November 21, 2016
BOARD OF COUNTY COMMISSIONERS
ORANGE COUNTY, FLORIDA
Addendum No. 2, IFB Y17-713-CC
BARNETT PARK AIR HANDLING UNITS REPLACEMENT

1. Revision: The following attached drawings have been revised:

Project:
Barnett Park AHU Replacement

4 First Floor Mechanical Room Isometric

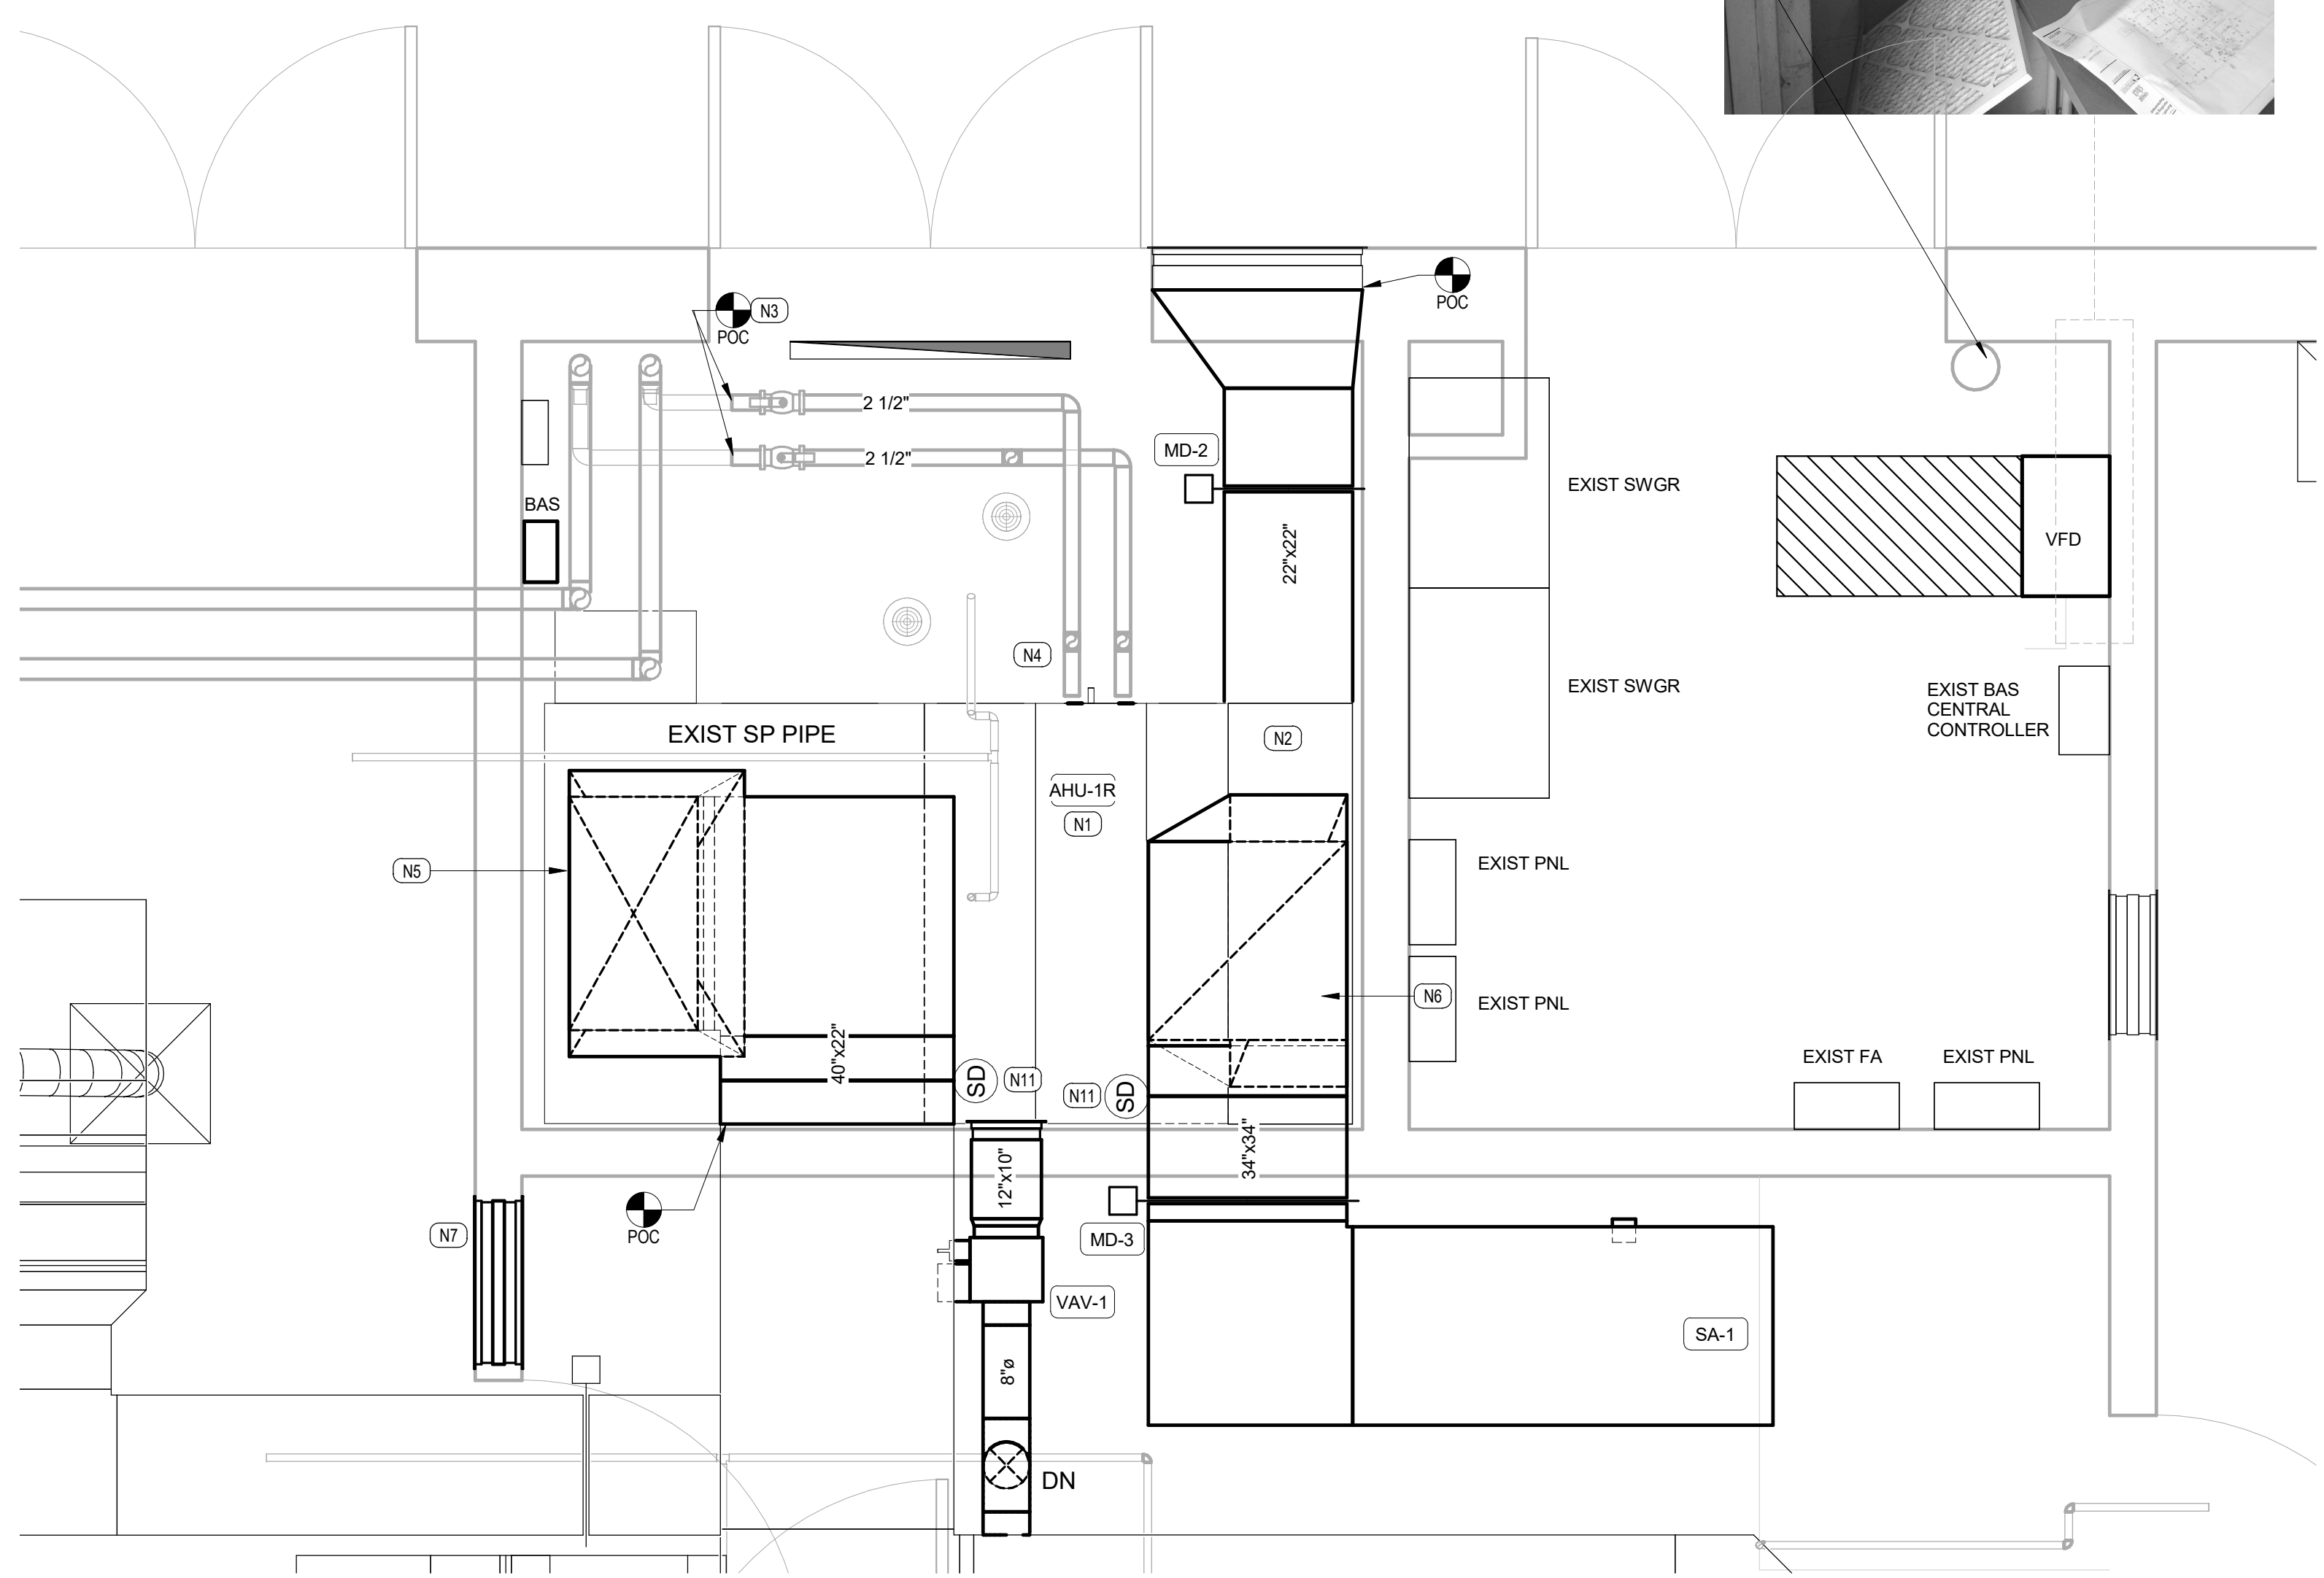
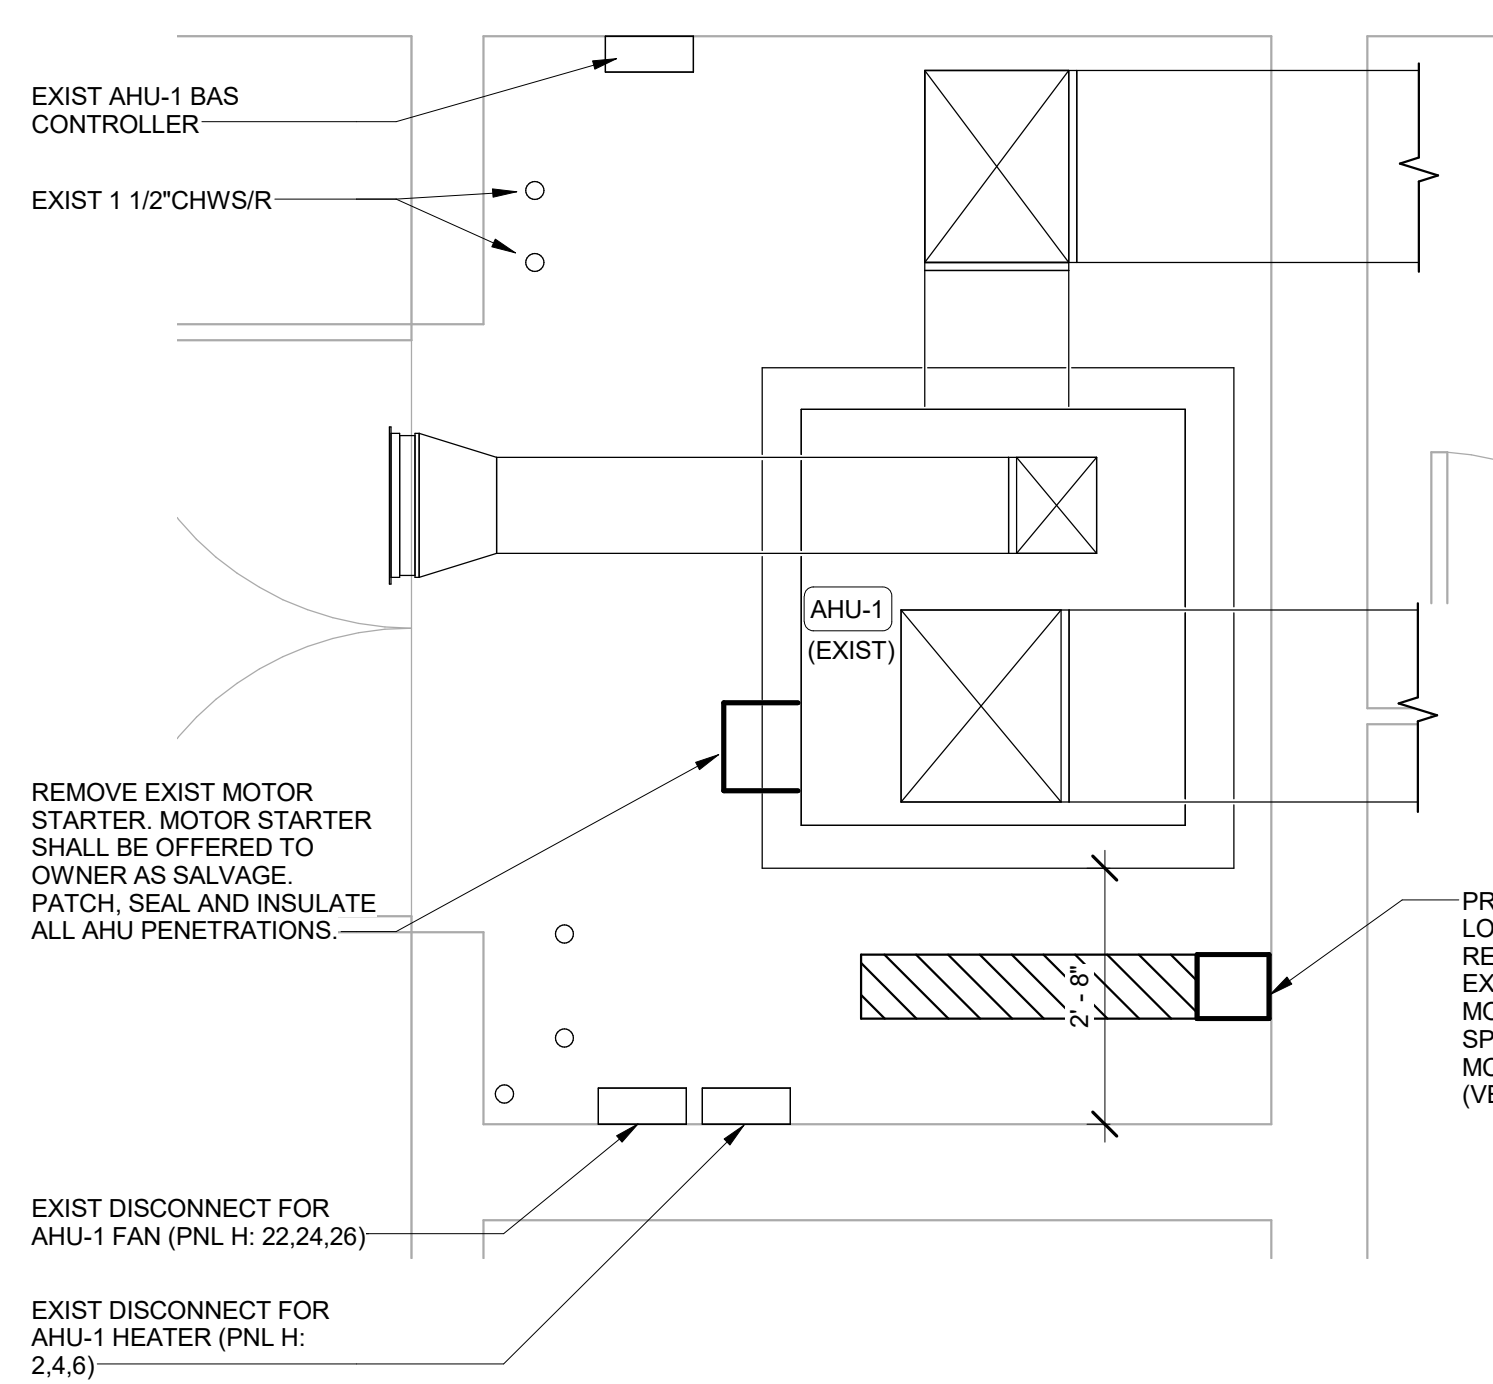
a. M202 dated 11/15/16 - Added fire dampers. Revised sound attenuator location.

6. **Question:** Drawing M202, on the second floor mechanical phasing plan, shows the sound attenuator being relocated in a fire wall. Is a fire damper not required? Please clarify.

11. Question: Drawing M202, New Plan Note N7 states to install a 36x36 transfer opening above a fire rated ceiling. What type of wall is the transfer going through CMU or drywall? And is it a fire rated wall? Please clarify.

Answer: Fire dampers will be required in wall. Sheet M202 has been revised to reflect this change.
7. **Question:** Drawing M103 states to reroute a vent pipe to accommodate the new duct. Please clarify the size and material of the vent pipe. Also, will rerouting require a new roof penetration?

Answer: The wall the transfer will be constructed in is CMU and the transfer opening will be constructed about the fire rated lid and does not require any fire dampers.
